APPLICATION NO.	FILING DATE	FIRST NAMED INVENTOR	ATTORNEY DOCKET NO.	CONFIRMATION NO.
10/806,760	03/22/2004	Marcel Thibault	2816-2A	2434

Office Action Summary

DETAILED ACTION

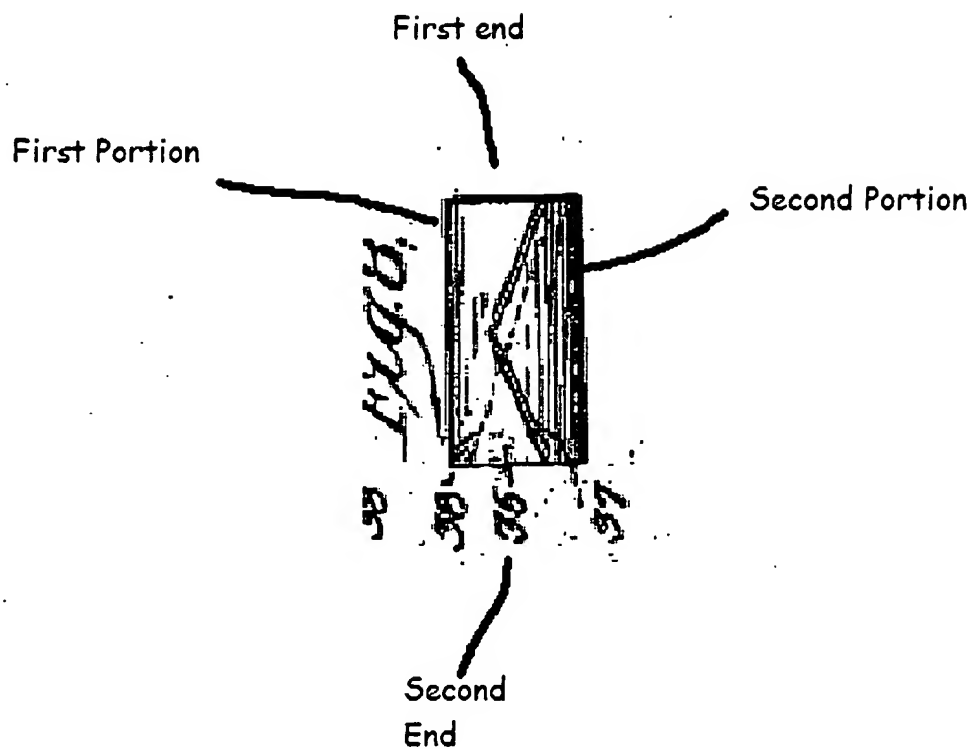
5. Claims 1, 6 (as best understood) and 8 are rejected under 35 U.S.C. 102(b) as being anticipated by Green (US Patent 1,552,054).

Green discloses a split bushing with a rod passing therethrough comprising first and second portions, a first end of each of said portions having a circumference which is less than 50% of the total bushing first end circumference, said second end of each of said portions having a circumference which is greater than 50% of the total bushing second end circumference, the arrangement being such that said first end of said first portion and said second end of said second portion form said first end of said bushing, and said second end of first portion and said first end of said second portion form said second end of said bushing. (see figure 8 and below)

Each of the first and second portions has first and second sidewalls extending between respective first and second ends having a generally accurate configuration.
